Address (list all addresses on the project site): 4725 Tradewinds Parkway
Title: Synbiotic Health

RE: 4725 Tradewinds Parkway
Urban Design Submittal / Upgrade

SYNBIOTIC
INTERIOR BUILD-OUT
4725 TRADEWINDS PARKWAY
MADISON, WI 53718

AS.1

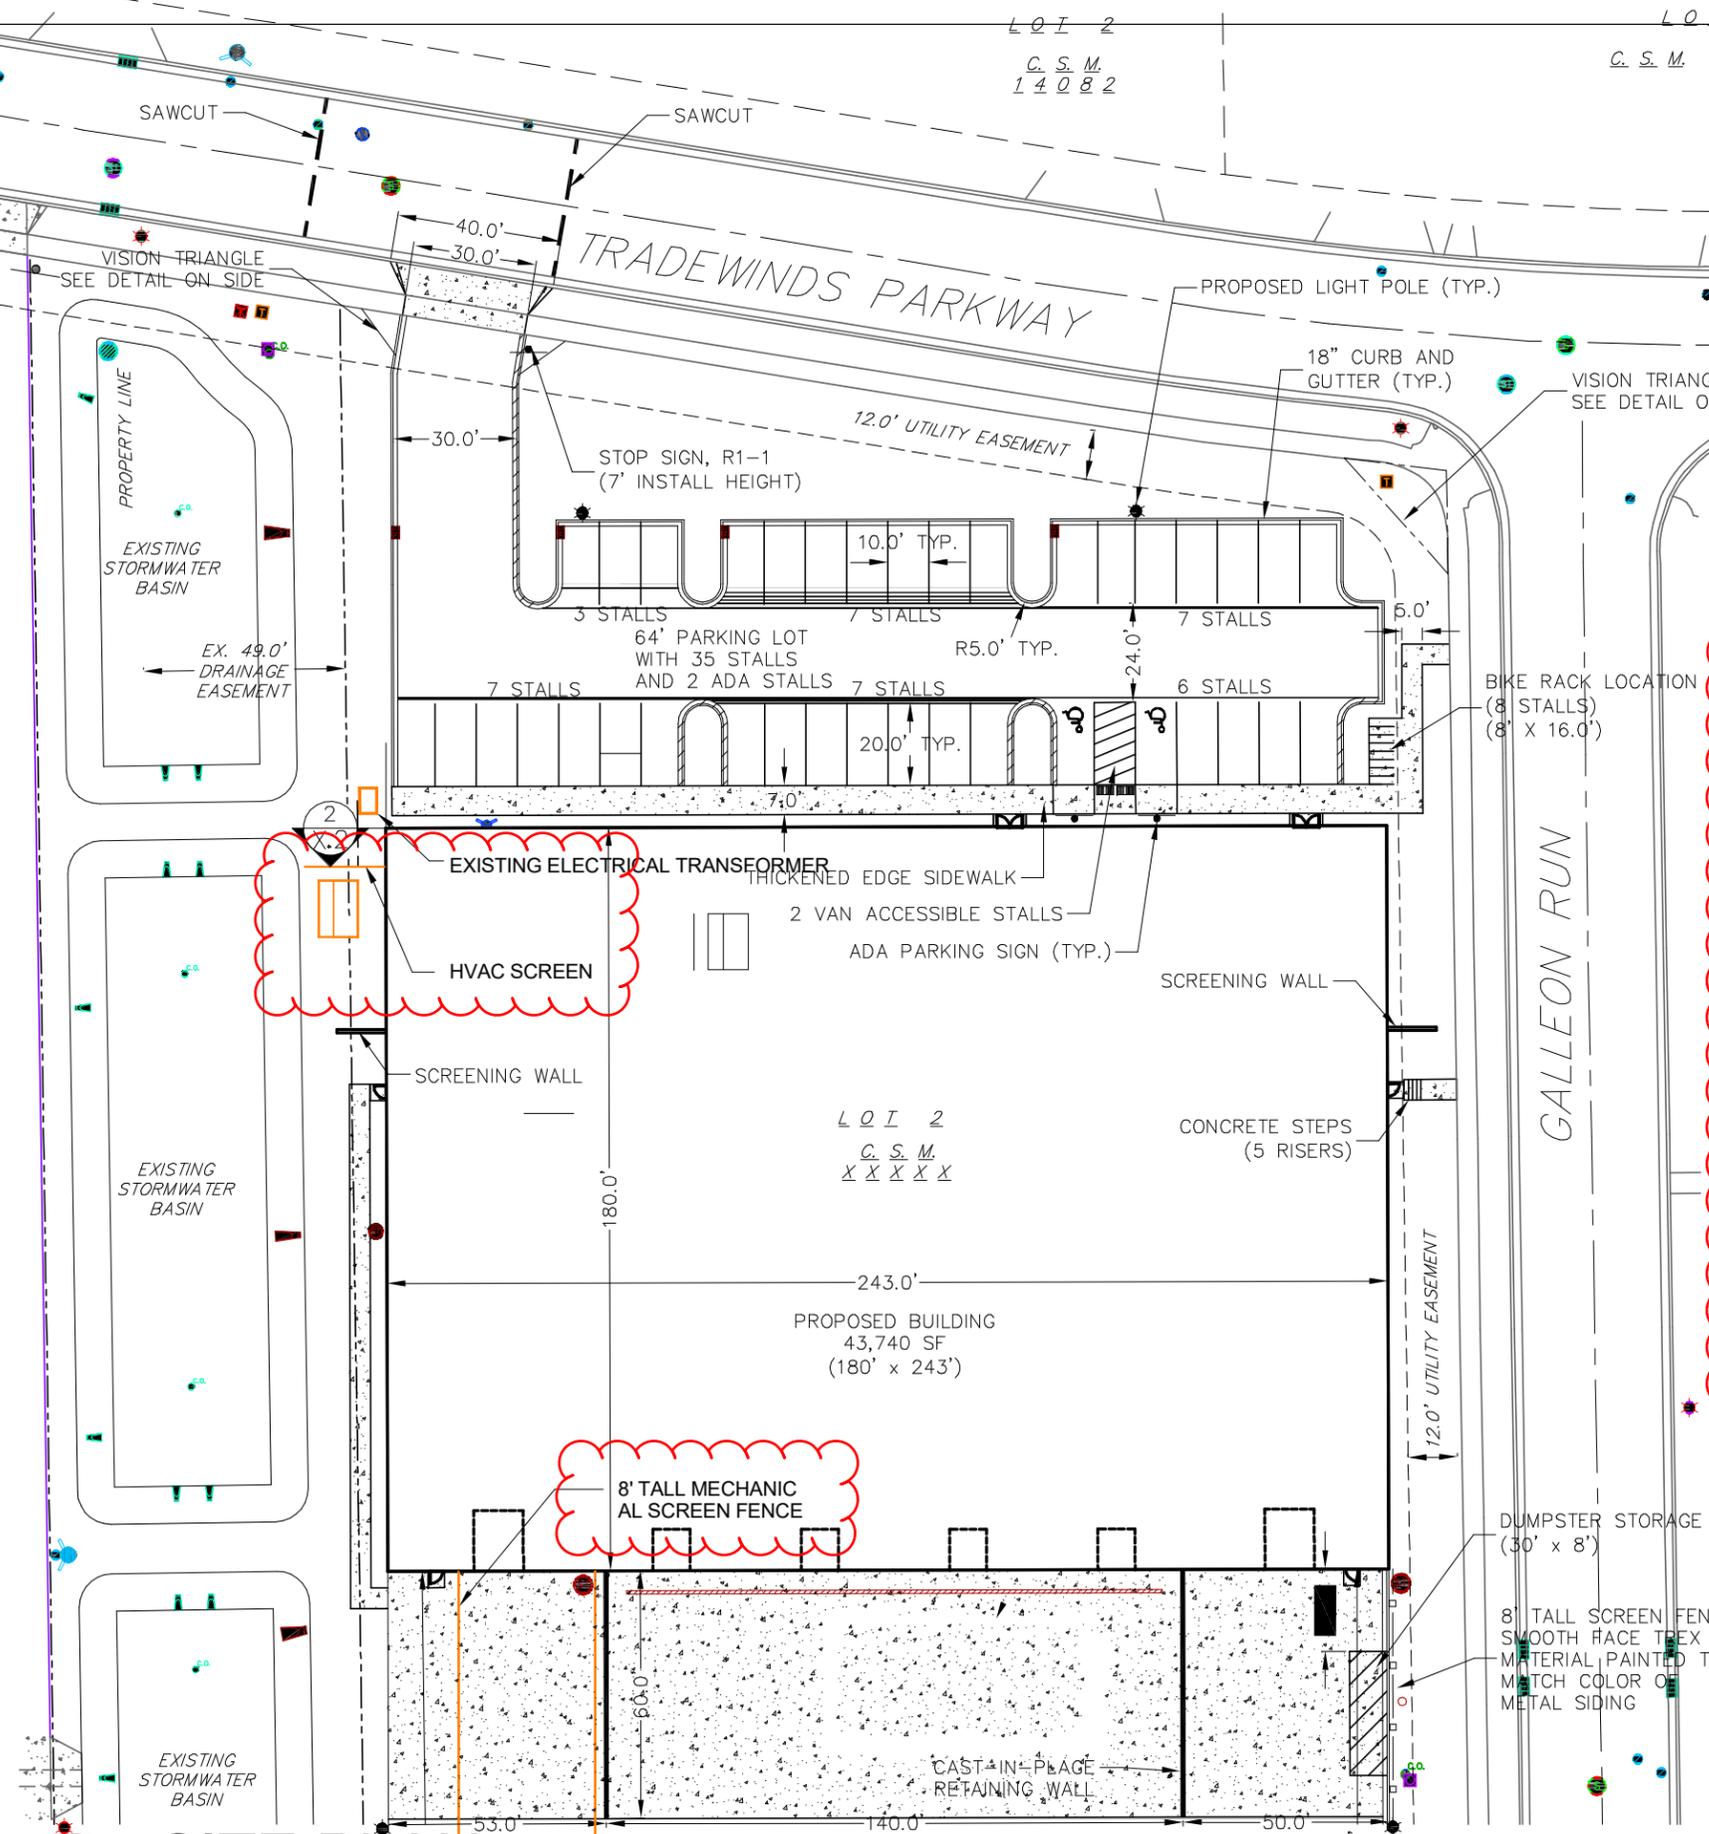
Site modifications (shown in attached plans) are minimal and include only the addition of screening fences for pad-mounted equipment. An hvac pad to be located on the west side of the building will be added and screened with both a complimentary metal screen fence, and evergreen trees as shown. Additional process equipment to eventually be located on the rear / south side of the building, on the existing concrete apron, will be screened with the same fence design.

PROPOSED ADD OF MECHANICAL SCREEN FENCE TO SITE PLAN 4/2023

LANDSCAPE

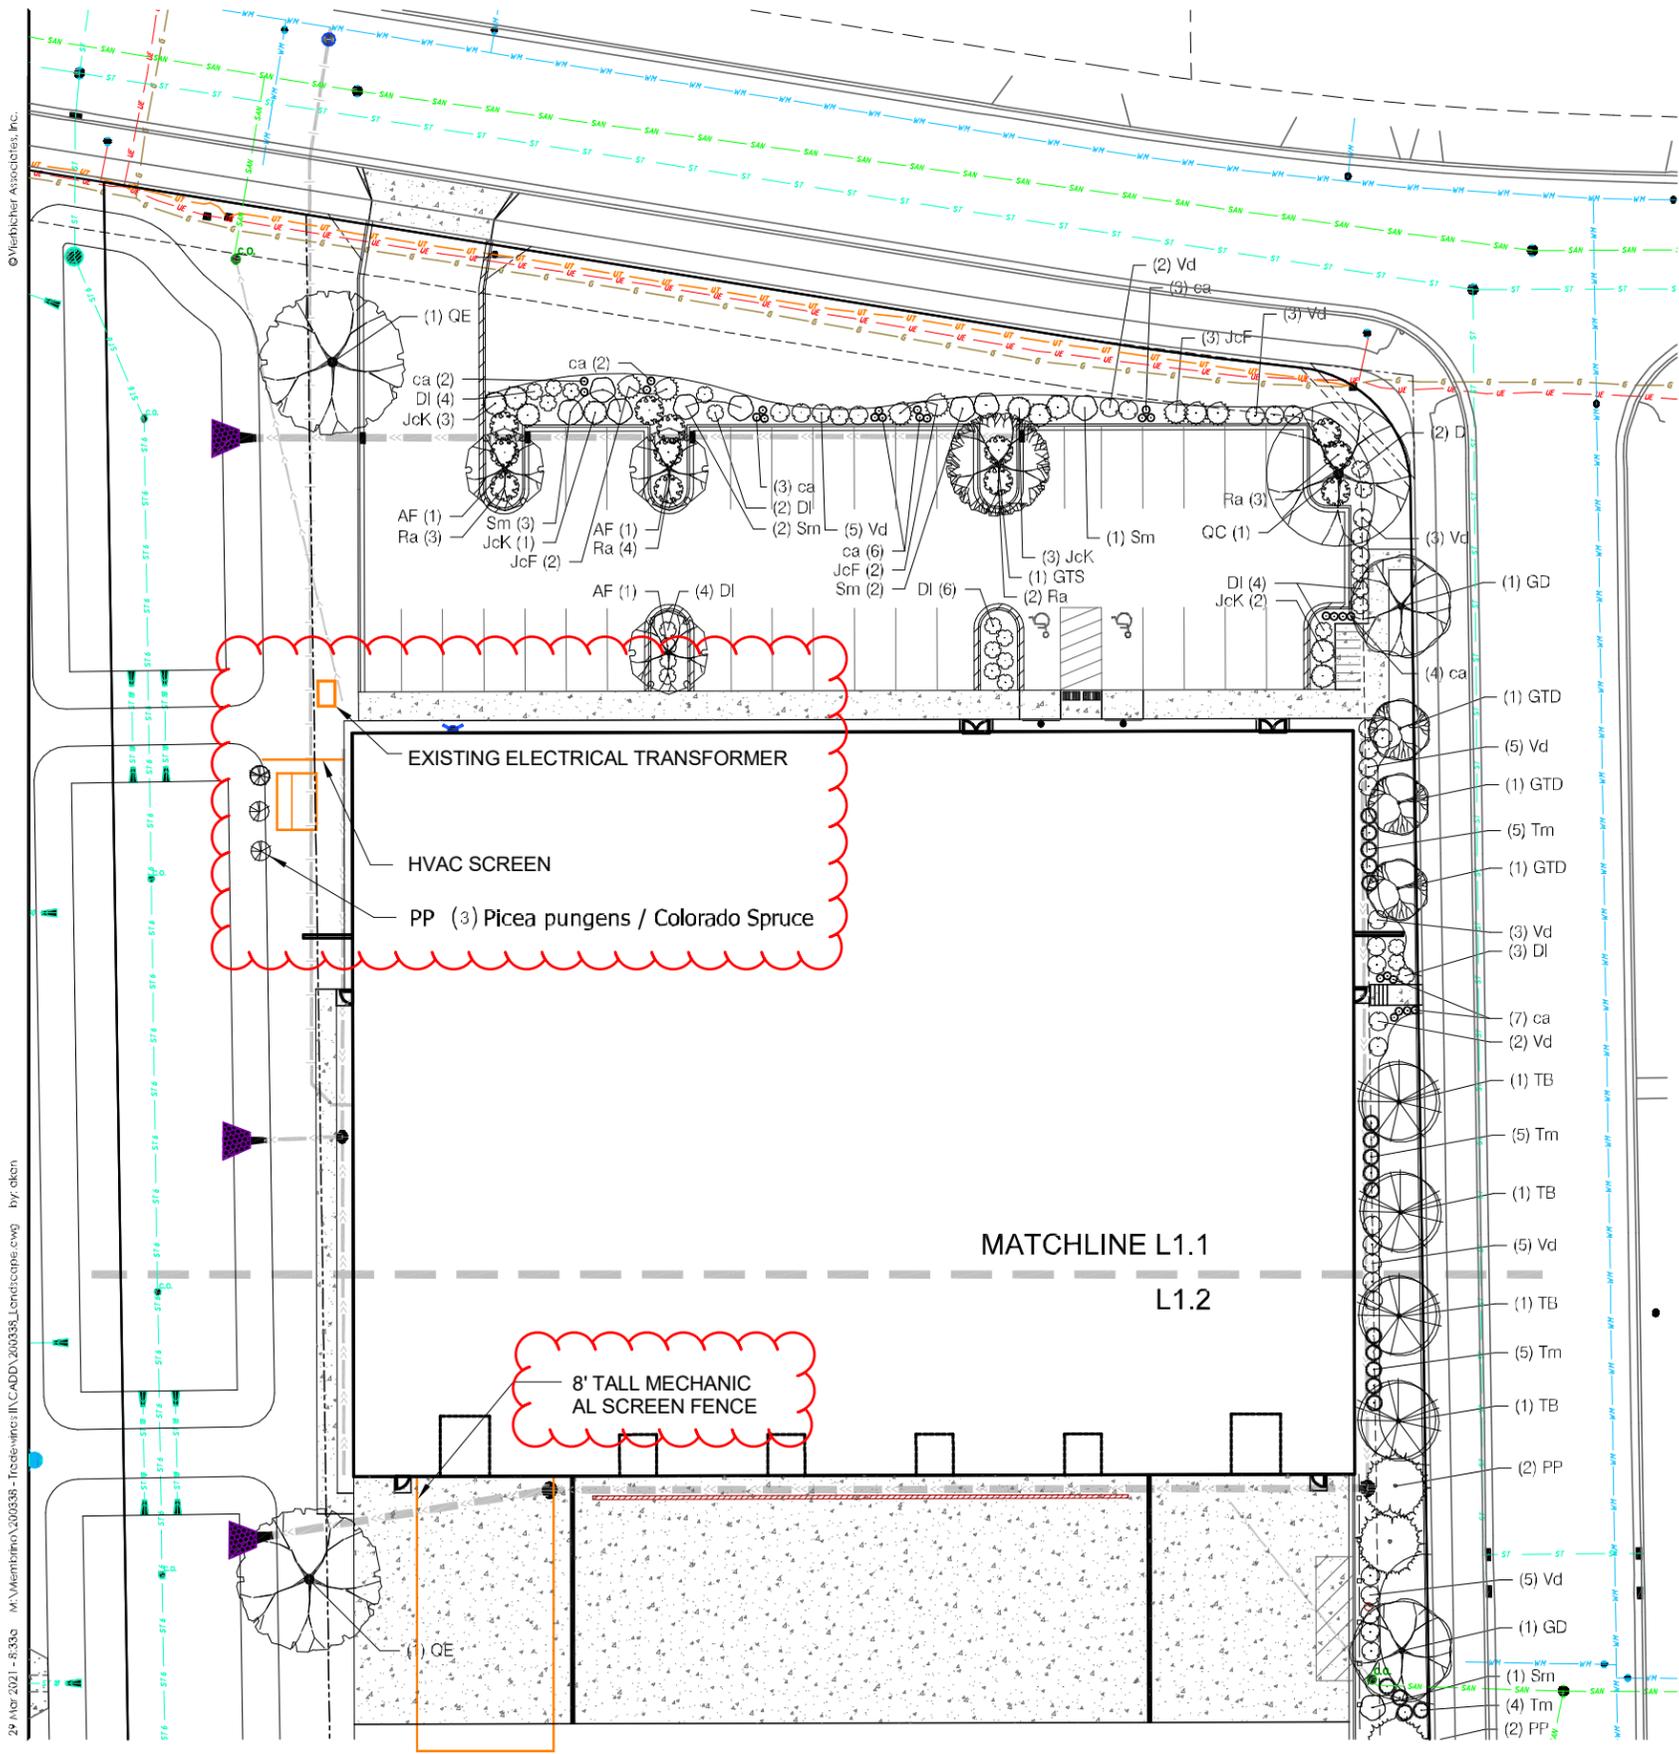
PROPOSED ADD OF MECHANICAL SCREEN FENCE AND EVERGREEN SCREENING. 4/2023

EAST ELEVATION

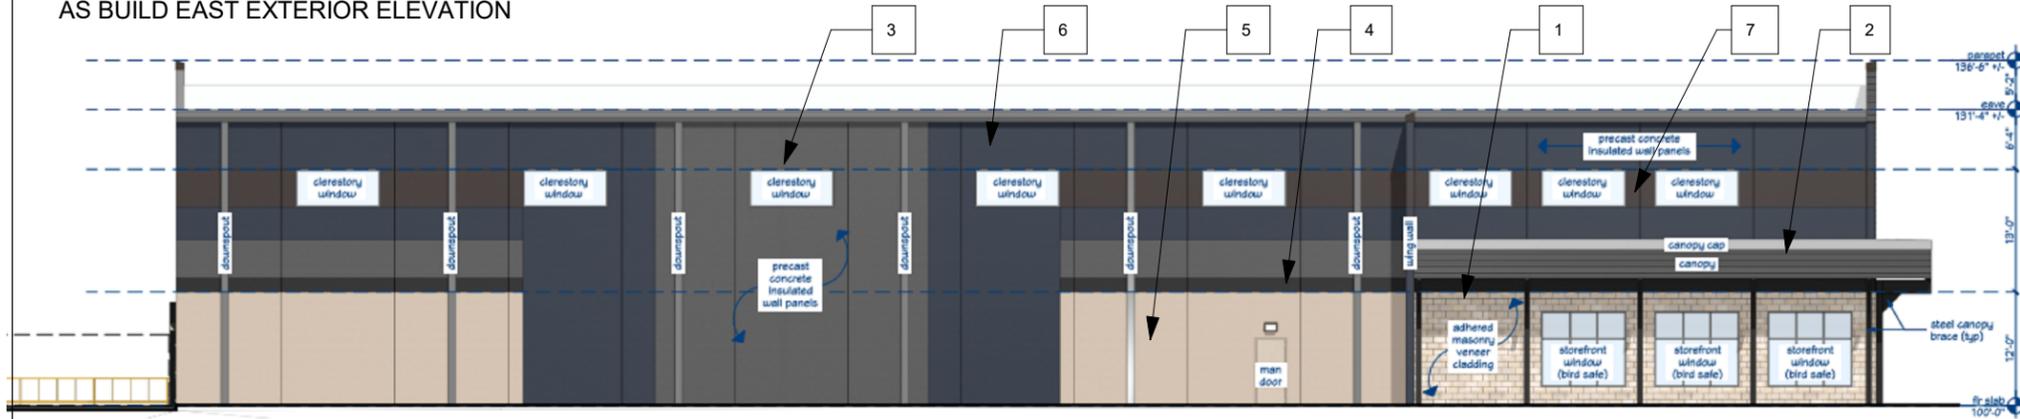
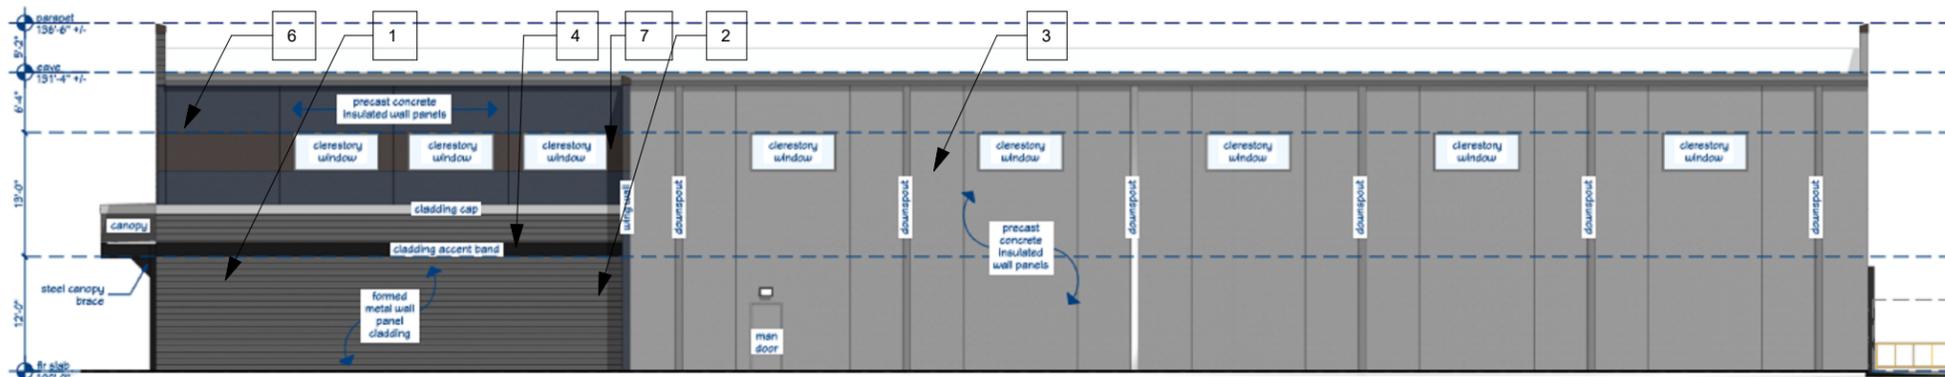
Our exterior shell design will include slight alteration of material placement, slight color change, windows to be relocated to locations previously identified as ‘future’, and mechanical unit

screening at grade. We are trying to remain true to the spirit of the original approval, but adding back the metal panels and window locations that were previously approved, as well as a canopy structure over the new tenant entry door.

WEST
ELEVATION

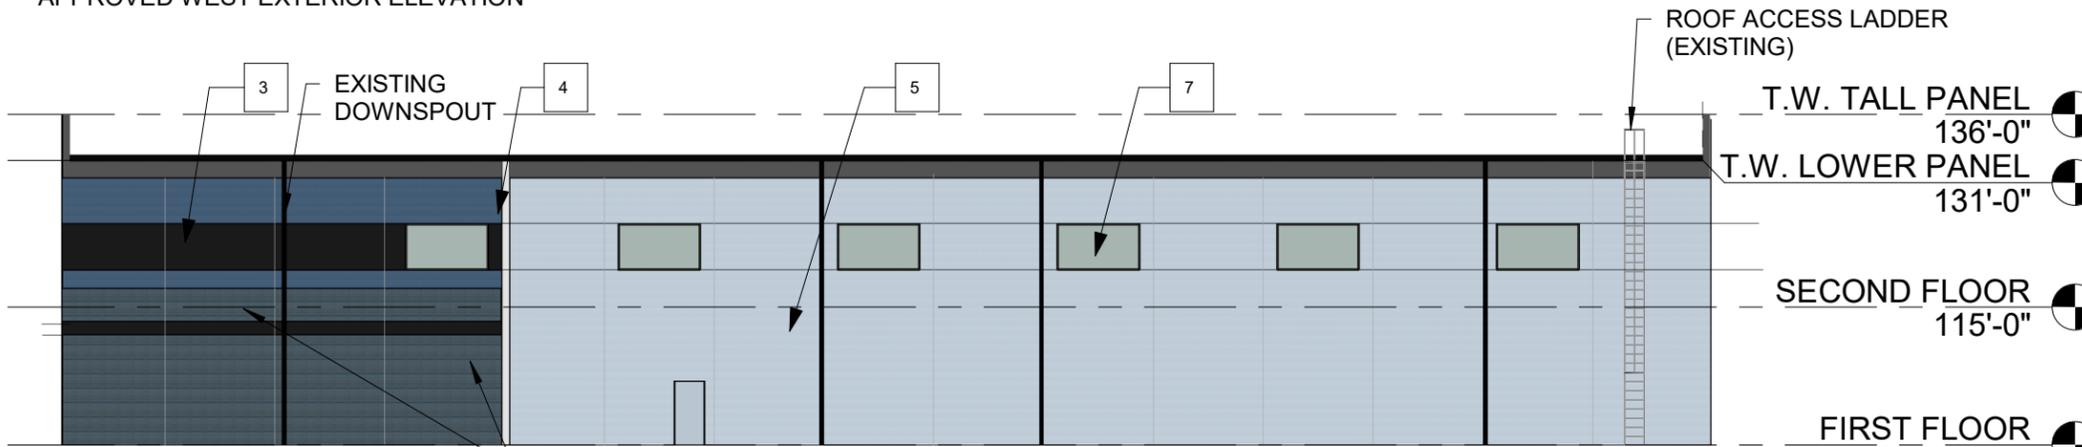
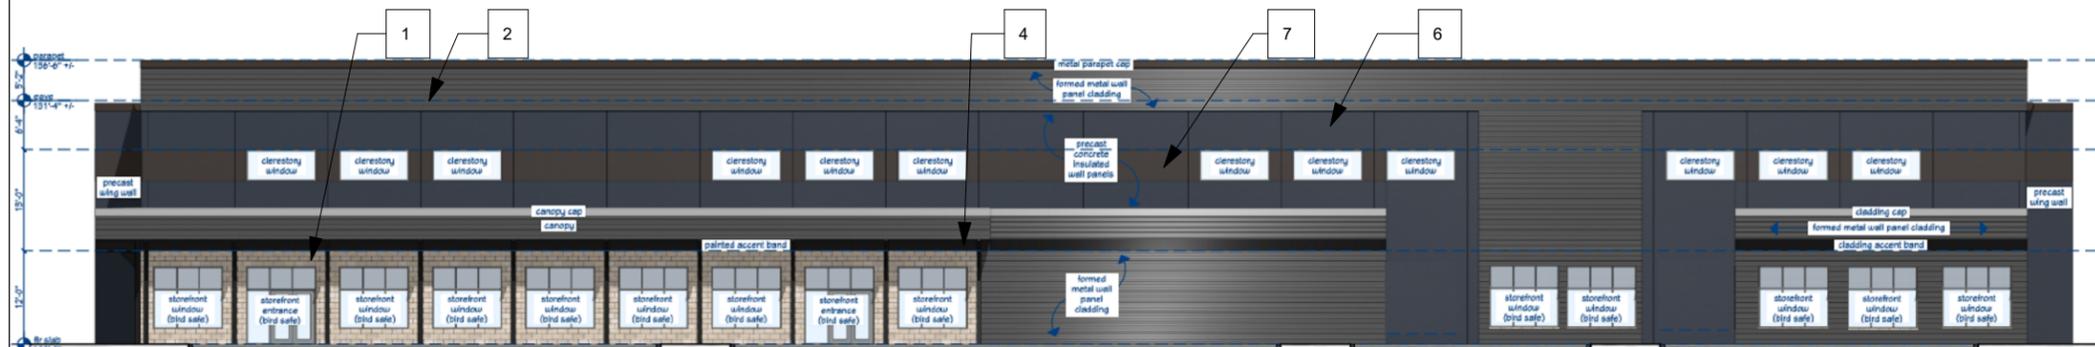
PROPOSED WEST EXTERIOR ELEVATION
ADD METAL PANEL TO WALL AND COVER THE FUTURE FRAMED OPENINGS
